PRELIMINARY BRIDGE SELECTION REPORT

**Sunset Road
Interstate 10 to River Rd**

Sunset Rd over Union Pacific Railroad (UPRR)

DESIGN & PLAN REVIEW COMMENTS

MIN. CONSTR. CLEARANCE ENVELOPE (NORMAL TO RAILROAD)

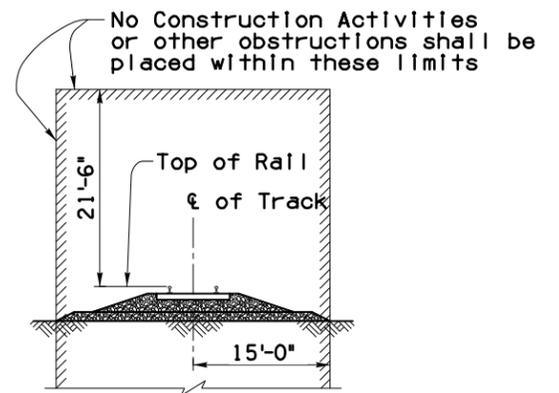
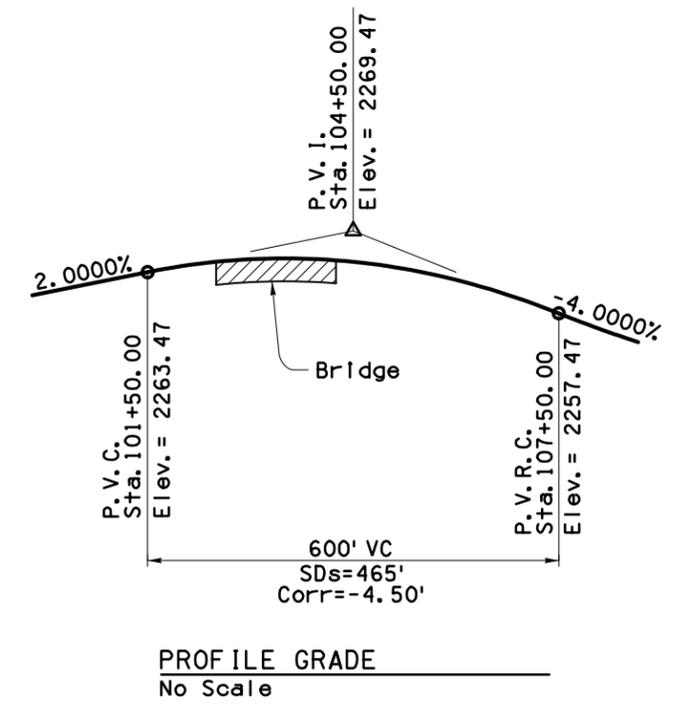
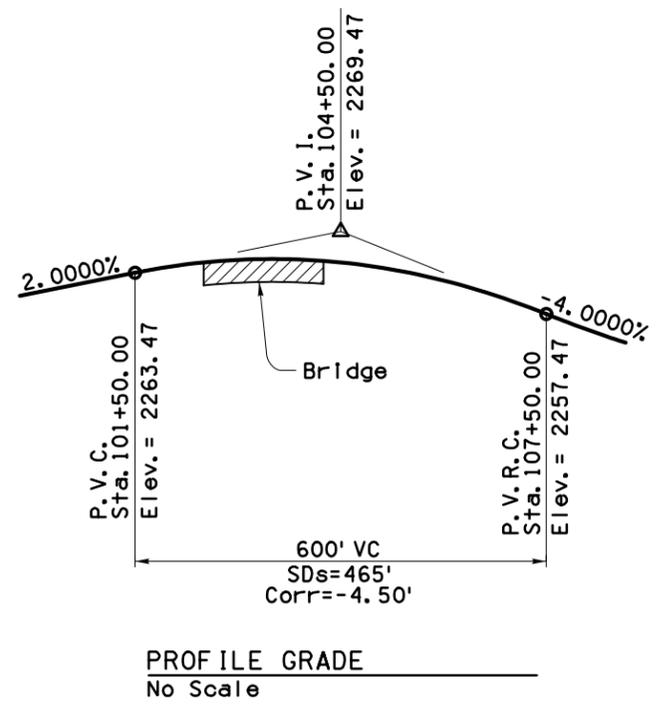
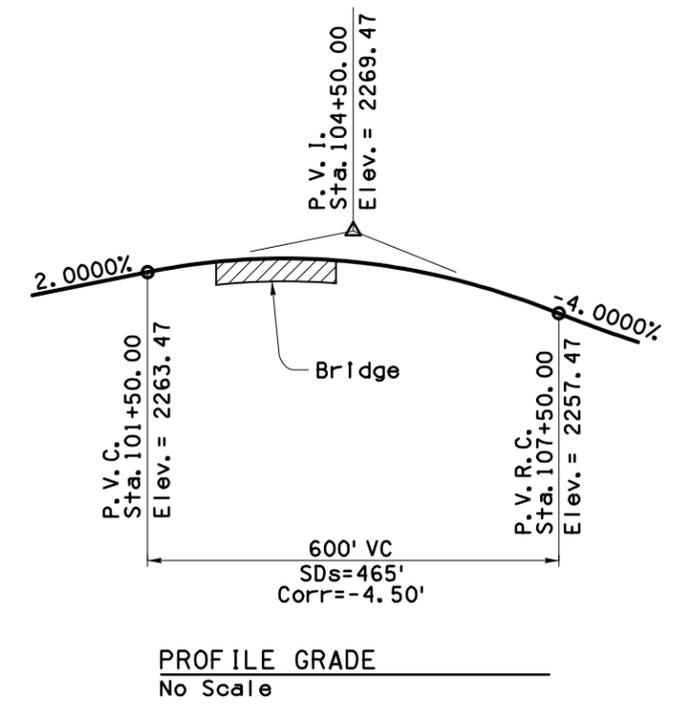
10.	General	Provide on the concept plans the Construction Clearance Envelope per UPRR STD Plan No. 711000. Refer to p. 36 of the UPRR/BNSF Guidelines for Railroad Grade Separation Projects.	TGM	Will add	No further comment at this time.	TGM		Closed

11.	General	In all profile views, define the width and height of the Construction Clearance Envelope per UPRR STD Plan No. 711000. Refer to p. 36 of the UPRR/BNSF Guidelines for Railroad Grade Separation Projects. Show the clearance envelope on all tracks, existing and future.	TGM	Will add	Please provide on future submittals. This comment will remain open for review at the next milestone submittal.	TGM		Open

GENERAL PLAN
 1"=20'
 New 2-Span Steel Plate Girder Bridge
 Skew = 0° 00' 00"
 Contour Interval = 1 ft.

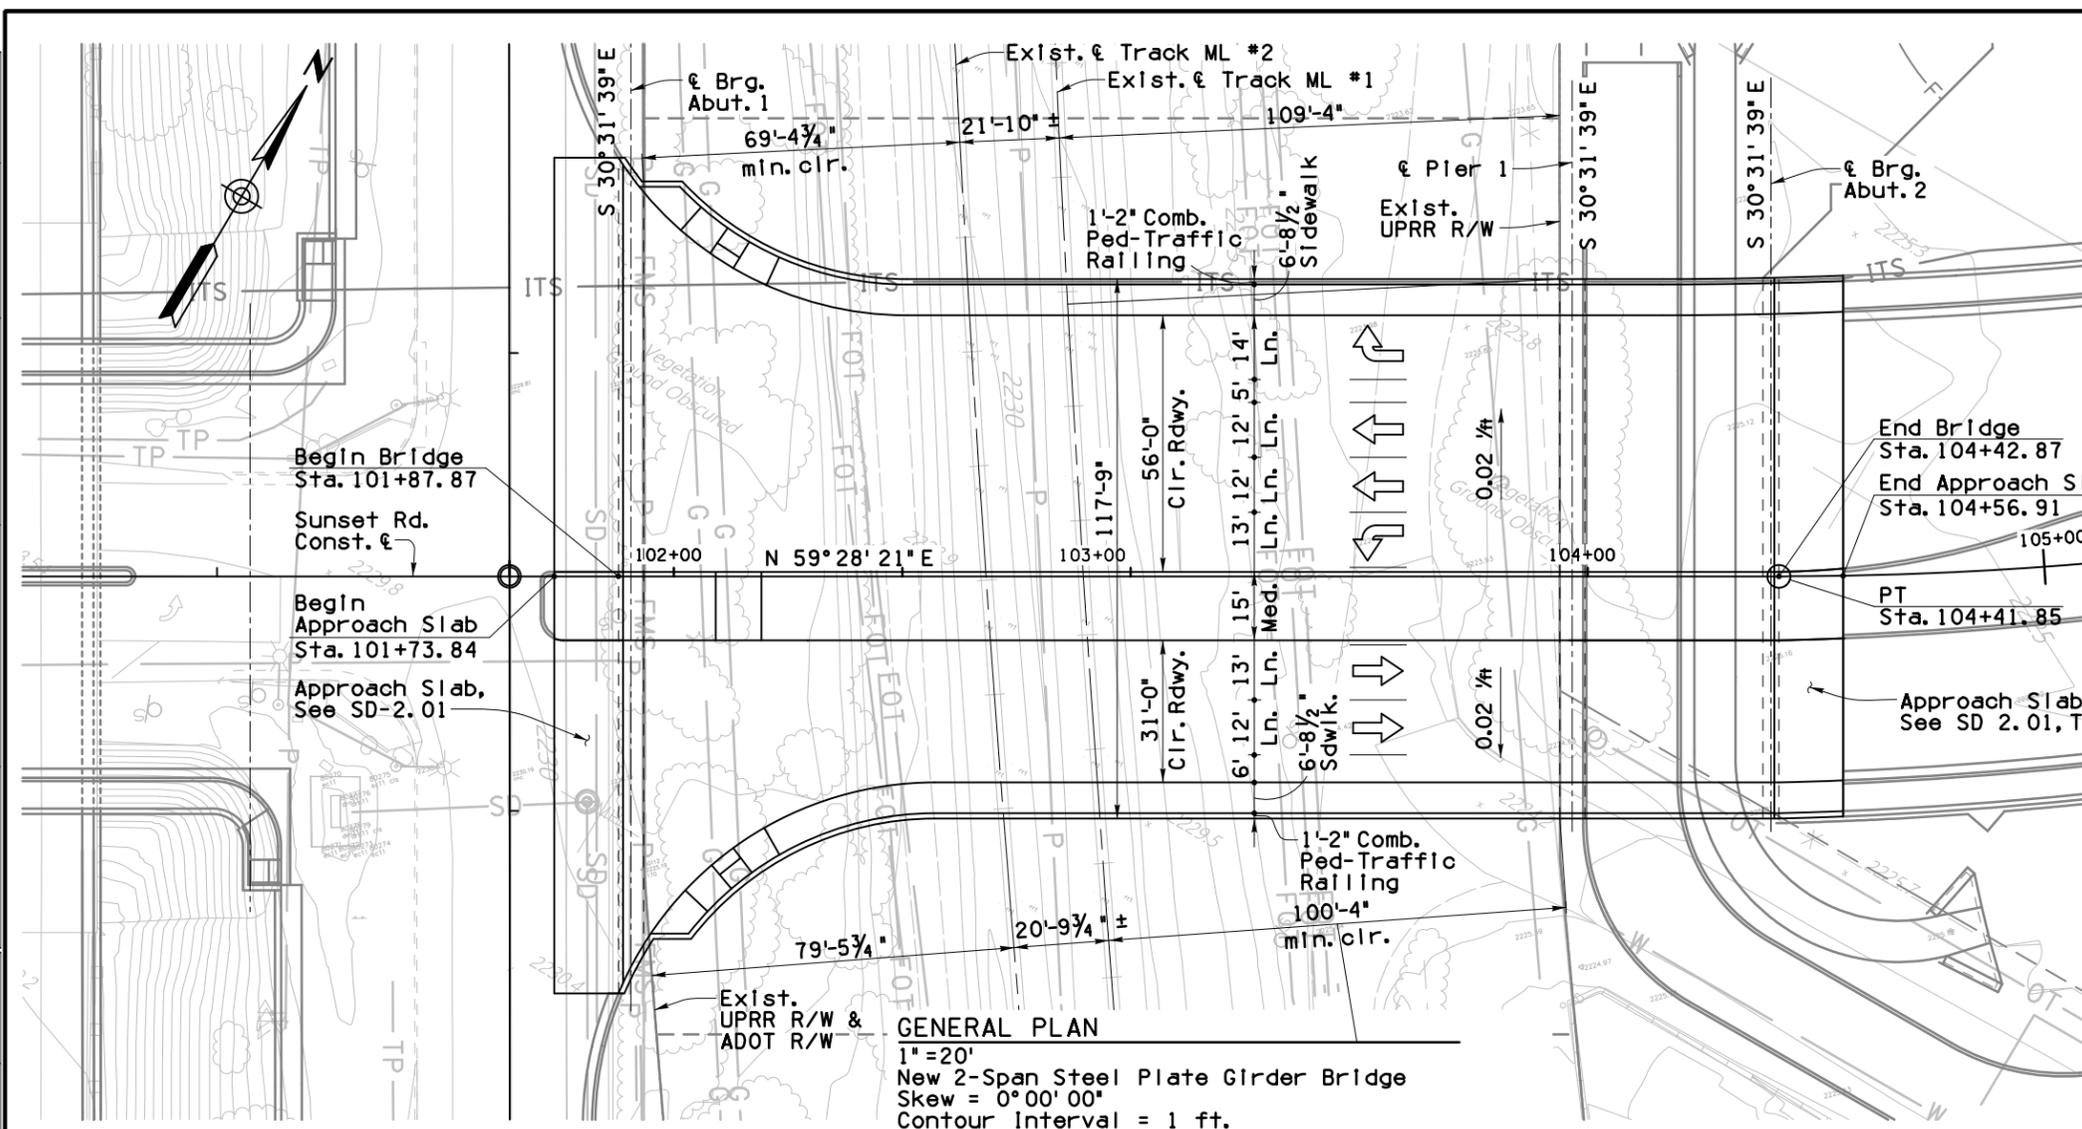
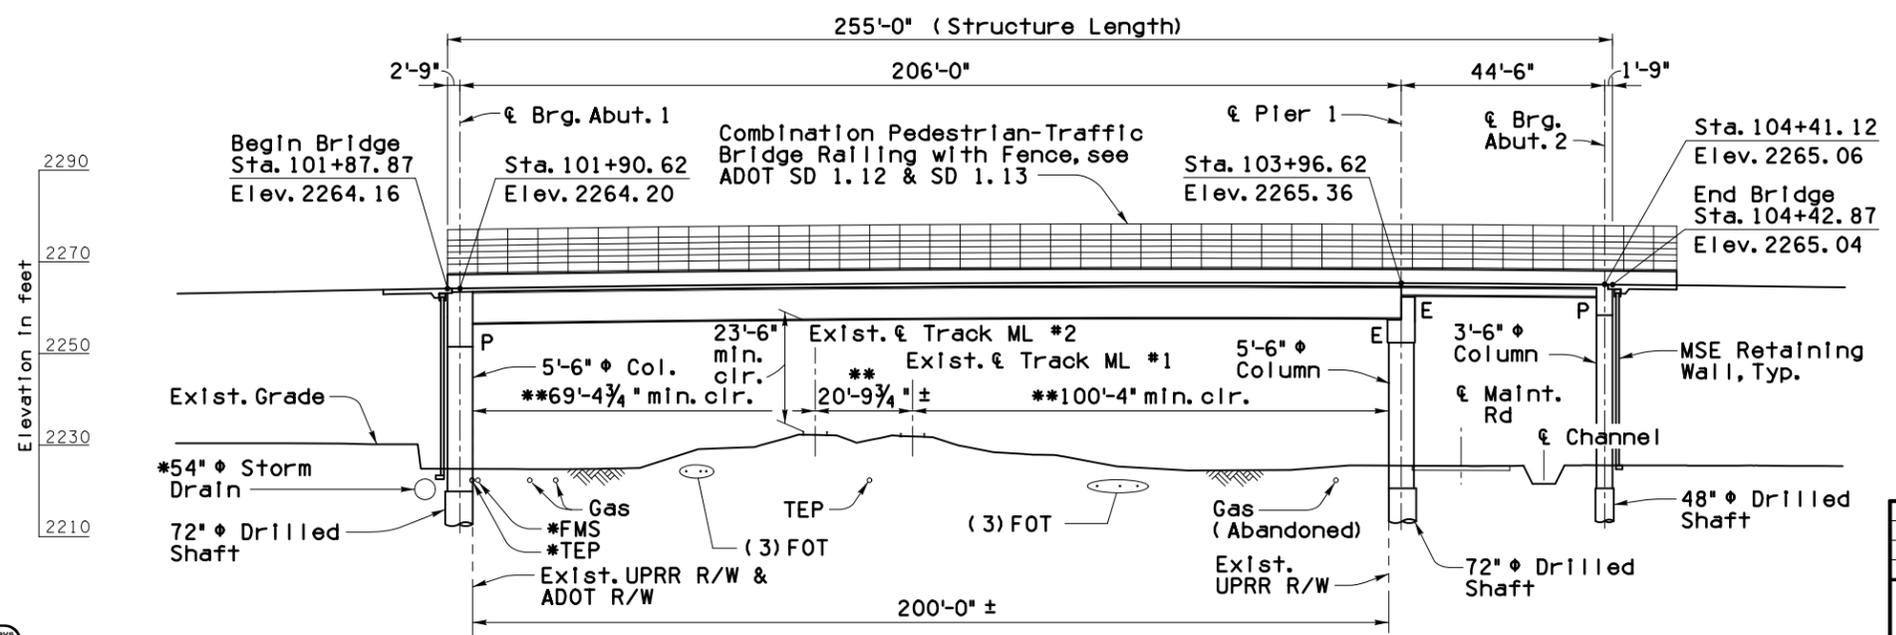
2.	Status	Alternative 1 proposes a steel plate girder superstructure spanning UPRR Right-of-Way. This option was not listed on p. 11 of 22 of the Preliminary Bridge Selection Report as a recommended alternative. However, it is the only alternative that UPRR Structures will currently consider for this proposed grade separation as it is the only one that meets Art. 5.1c of the UPRR/BNSF Guidelines for Railroad Grade Separation Projects. Variances to these guidelines are not being considered since an alternative that meets these requirements is feasible. Revise the concept submittal package as required for Alternative 1 or provide another option meeting all requirements of the UPRR/BNSF Guidelines for Railroad Grade Separation Projects. Coordinate with Comments 3 & 4. Note, cost shall not be the determining factor as outlined in Section 3.2 and 4.1 of the UPRR/BNSF Guidelines for Railroad Grade Separation Projects.	TGM	Will modify	No further comment at this time.	TGM		Submittal Status

6.	General	Review proposed location and geometry of all substructures. Verify there are no above-ground encroachments (piers, bents, columns) or below-ground encroachments (piles, foundations/footings) on UPRR Right-of-Way.	TGM	verified	It appears that UPRR's 07/22/20 comment has not been addressed. The proposed 72" diameter drilled shafts provided on the General Plan & Elevation, p. 13 of 27 of the submittal package, appear to encroach on UPRR Right-of-Way. Review and revise as required to comply. Coordinate with comment 8.	TGM	The proposed 72" diam drilled shaft(s) is intended to line up with the front face of pier/abutment and does not encroach into UPRR Right-of-Way.	Open

7.	General	Provide dimension strings in plan view to define limits of Railroad Right-of-Way with respect to centerlines of mainline tracks per UPRR STD Plan No. 711100 Sheet 2. Refer to p. 38 of the UPRR/BNSF Guidelines for Railroad Grade Separation Projects.	TGM	Will add	No further comment at this time.	TGM		Closed

8.	General	Provide dimension strings in plan and elevation views to define horizontal clearances measured perpendicularly from centerline of the nearest track to the face of obstruction (i.e. substructure above grade, foundation below grade, etc.) per UPRR STD Plan No. 711100 Sheet 2. Refer to p. 38 of the UPRR/BNSF Guidelines for Railroad Grade Separation Projects.	TGM	Will add	It appears that UPRR's 07/22/20 comment has not been fully addressed. Provide dimensions showing all substructure components, including the proposed 72" diameter drilled shafts, do not encroach on UPRR Right-of-Way. Review and revise as required to comply. Coordinate with comment 6.	TGM	The proposed 72" diam drilled shaft(s) is intended to line up with the front face of pier/abutment and does not encroach into UPRR Right-of-Way.	Open

9.	General	Provide dimension strings in plan and elevation views to define horizontal spacing measured perpendicularly between track centerlines per UPRR STD Plan No. 711100 Sheet 2. Call out each track by name (e.g. UPRR Mainline No. 1, UPRR Mainline No. 2, etc.). Refer to p. 38 of the UPRR/BNSF Guidelines for Railroad Grade Separation Projects.	TGM	Will add	No further comment at this time.	TGM		Closed

GENERAL PLAN
1"=20'
New 2-Span Precast-Prestressed Concrete BT82 Girder Bridge, with CIP PT Box Back Span
Skew = 0°00'00"
Contour Interval = 1 ft.

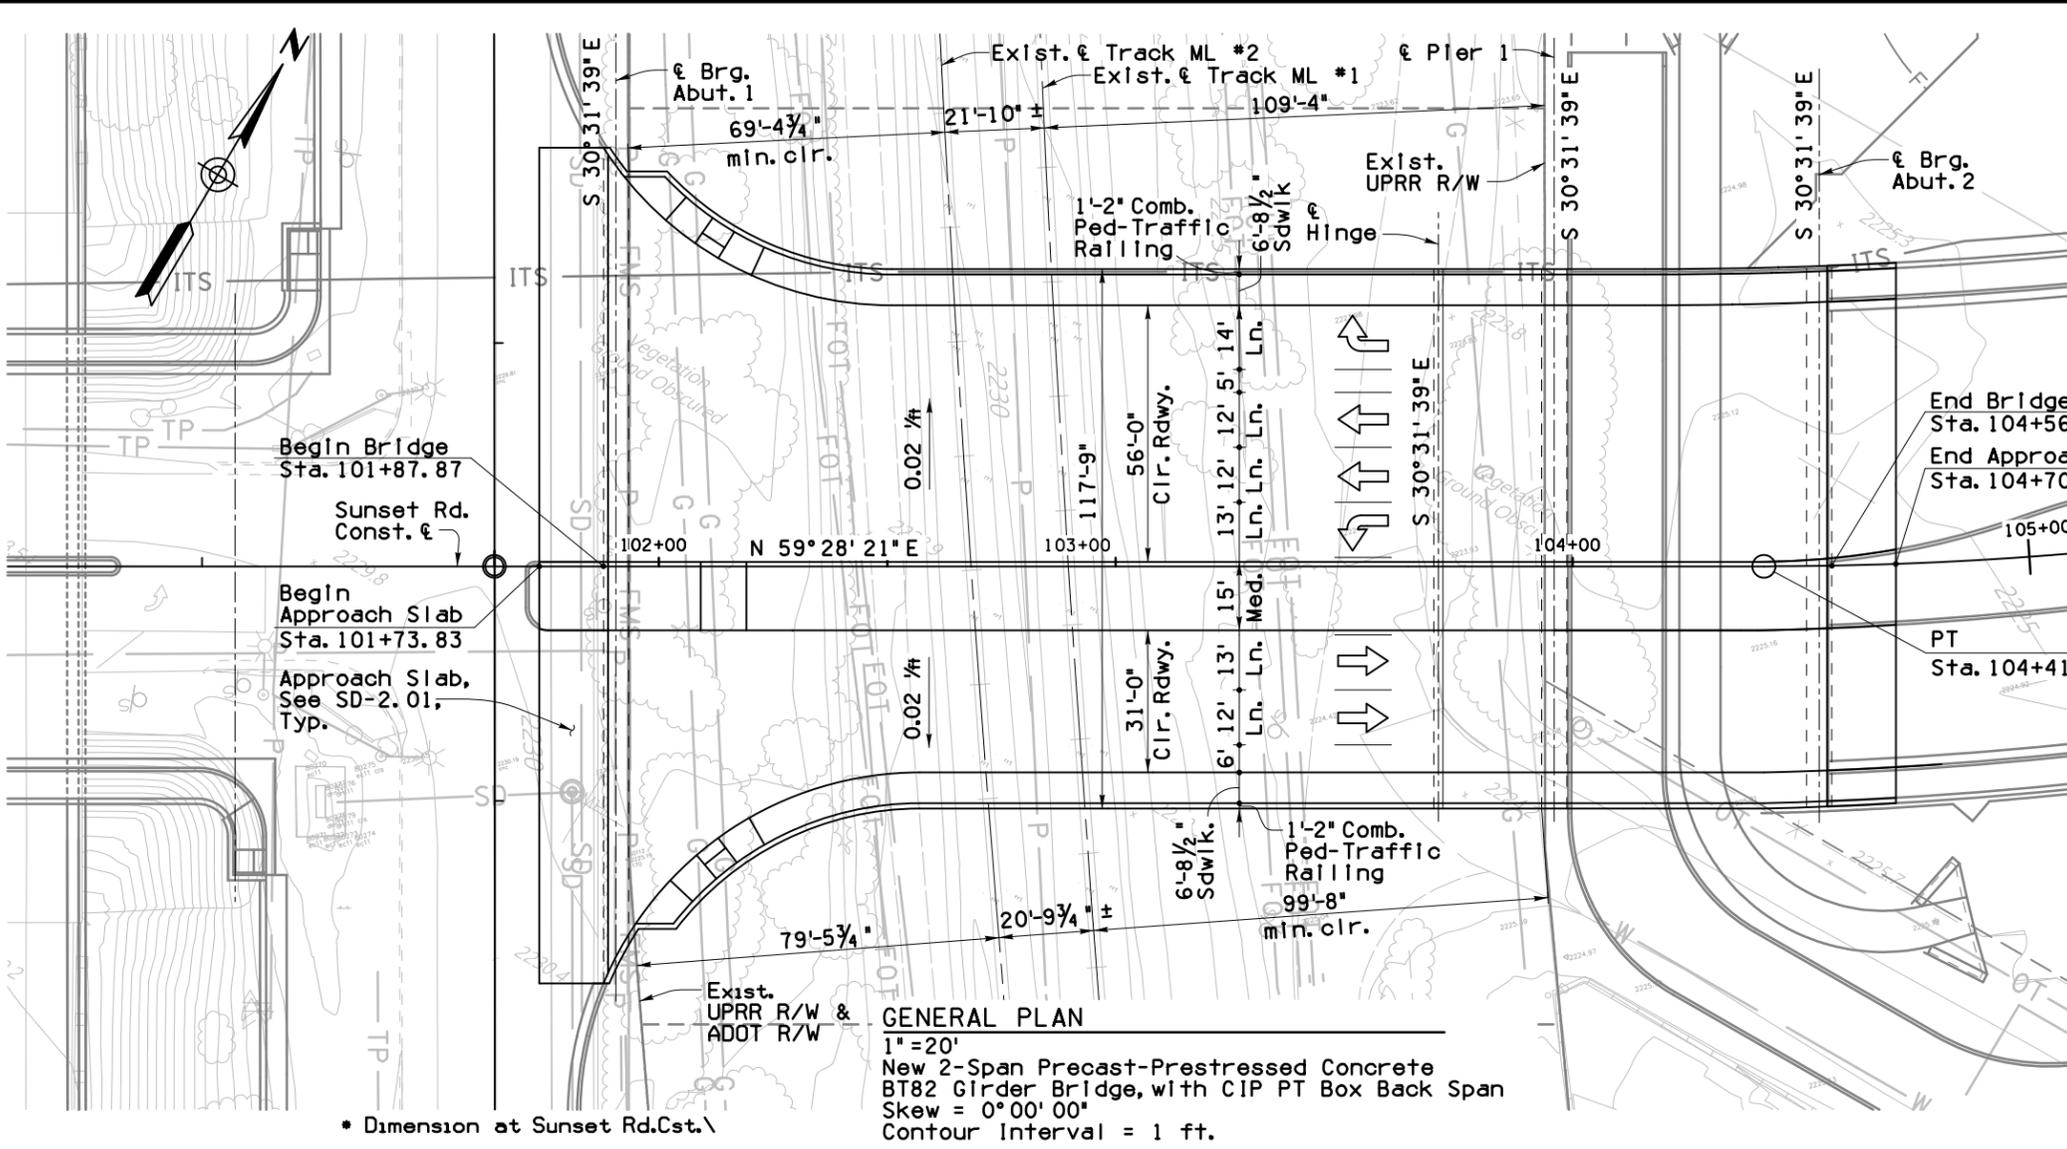
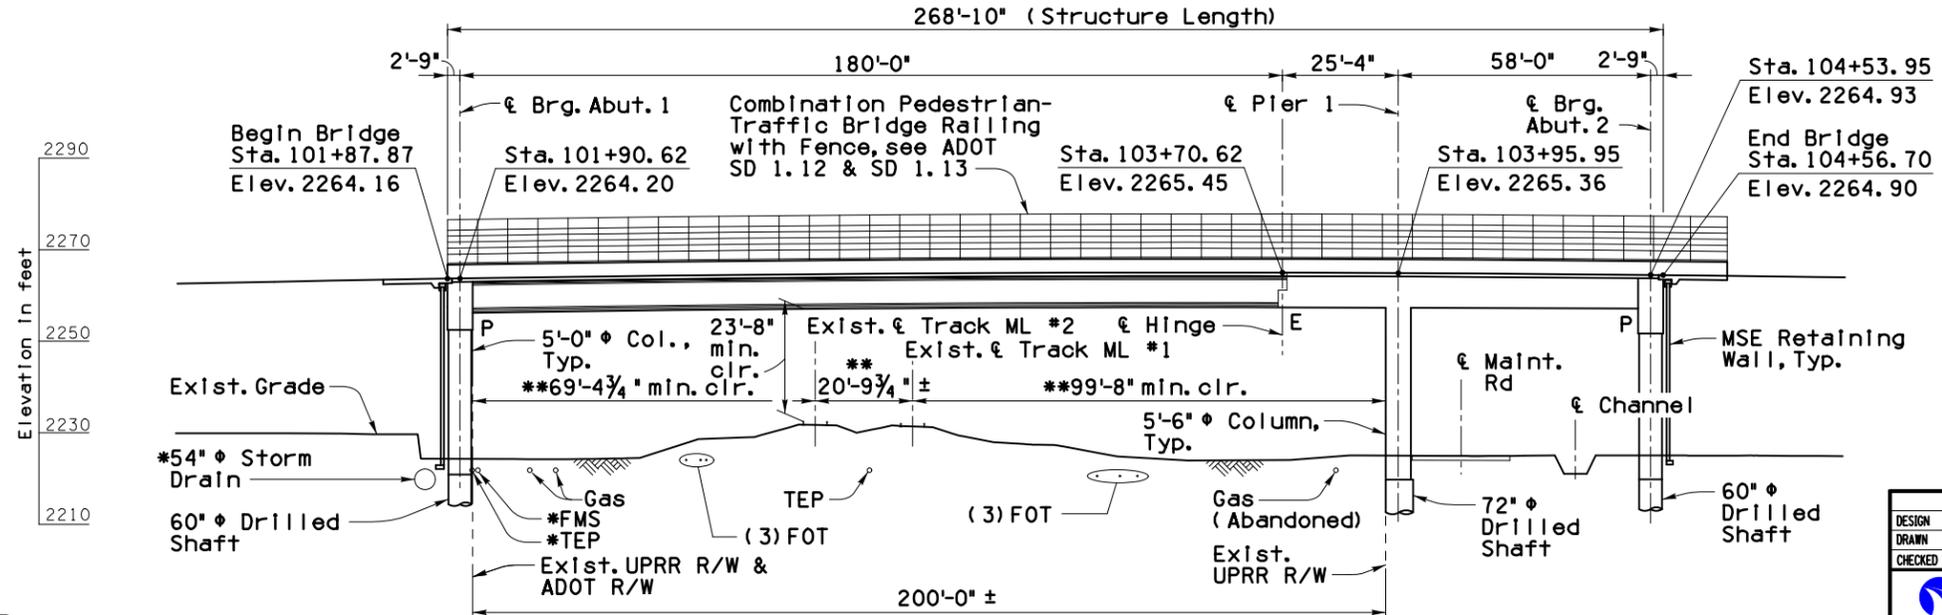
3.	Status	Alternative 2 proposes a superstructure consisting of precast concrete girders that transition to cast-in-place boxes using a hinge within UPRR Right-of-Way. The use of expansion or hinge joints for the Overhead Structure over Railroad tracks or inside Railroad Right-of-Way are not permitted per Art. 5.5.a of the UPRR/BNSF Guidelines for Railroad Grade Separation Projects. Consequently, current review status of Alternative 2 is 'REJECTED' .	TGM	Will modify	No further comment at this time.	TGM		Submittal Status
